ACME TOWNSHIP PLANNING COMMISSION MEETING
ACME TOWNSHIP HALL
6042 Acme Road, Williamsburg MI 49690
December 11th, 2017 7:00 p.m.

planning review

Request: Preliminary Approval for a Planned Development

The Applicant is resubmitting an application for a Planned Development based on comments received during a preliminary review in November 2016 and March 2017. The proposed concept plan envisions a retail/residential mixed use development with frontage on M-72 consistent with the Corridor Commercial (C) zoning designation and a series of resort-style neighborhoods within the interior of the site on property zoned Mixed Housing Neighborhood (MHN). The overall site is 20.40 acres in size and the CC zoning consists of 7.31 acres and the MHN zoning comprises 13.17 acres.

S.5

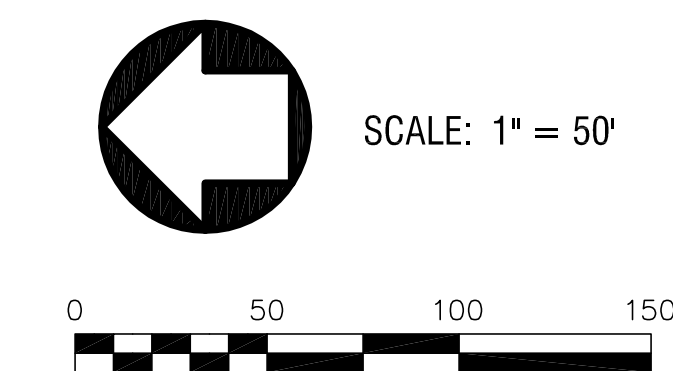
Location of all wetlands, water and watercourses, proposed water detention areas and depth to groundwater.	Sheet 5 notes the location of ecologically sensitive areas including delineated wetland boundaries. Sheet 23 addresses the storm water collection system, location of ponds and utilization of rain gardens. Although not required as part of this phase, the Township Engineer has been asked to perform a general review of the proposed stormwater network. The Applicant has been briefed, and is well aware, of the water quality issues associated with Acme Creek. It has been recommended that prior to implementation and during construction that water quality samples be undertaken periodically in the same fashion as GTTC.
The boundaries of open space areas that are to be preserved or reserved and an indication of the proposed ownership.	Sheet 7 provides a framework where open space within the development will occur. Sheet 24 illustrates the location of park and open space within the development. All open space is within the boundaries of the development.

S.24

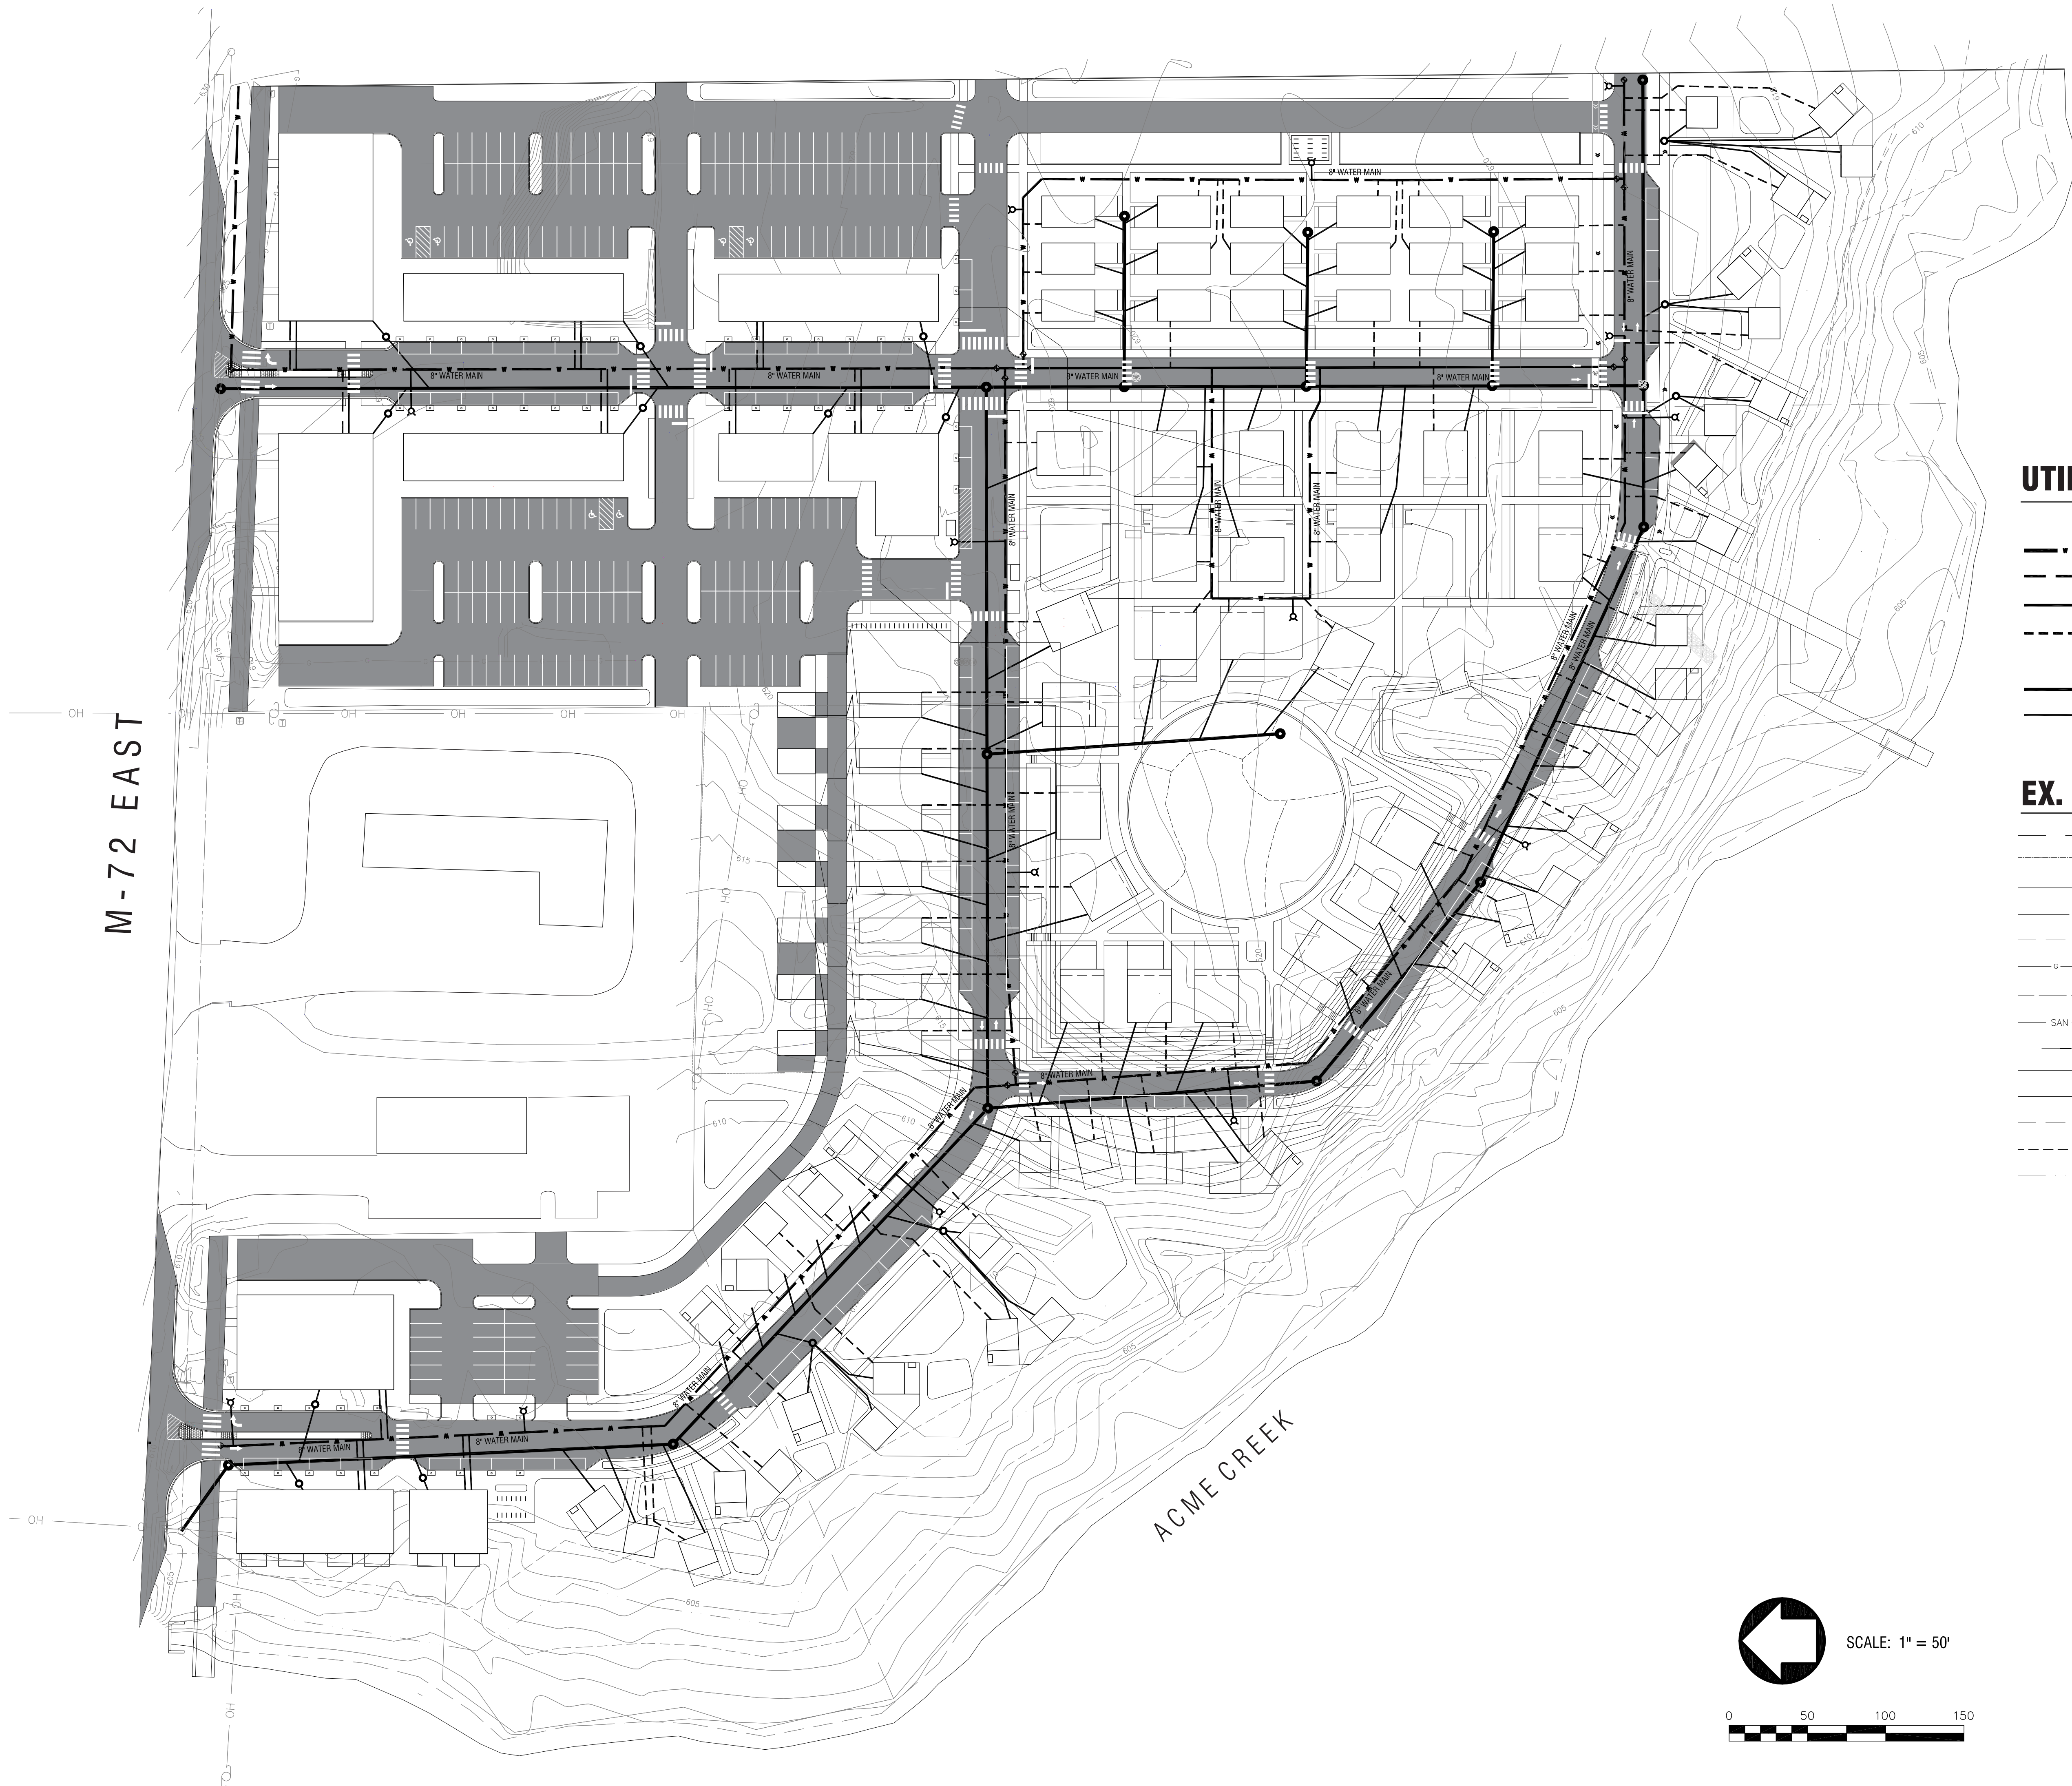
A schematic landscape treatment plan for open space areas, streets and border/transition areas to adjoining properties.	Sheets 19 through 22 illustrate the landscape treatment along internal streets and Sheet 24 notes the open space provided within the site, much of which is provided through the preservation of the existing tree cover, and setbacks from Acme Creek and delineated wetlands.
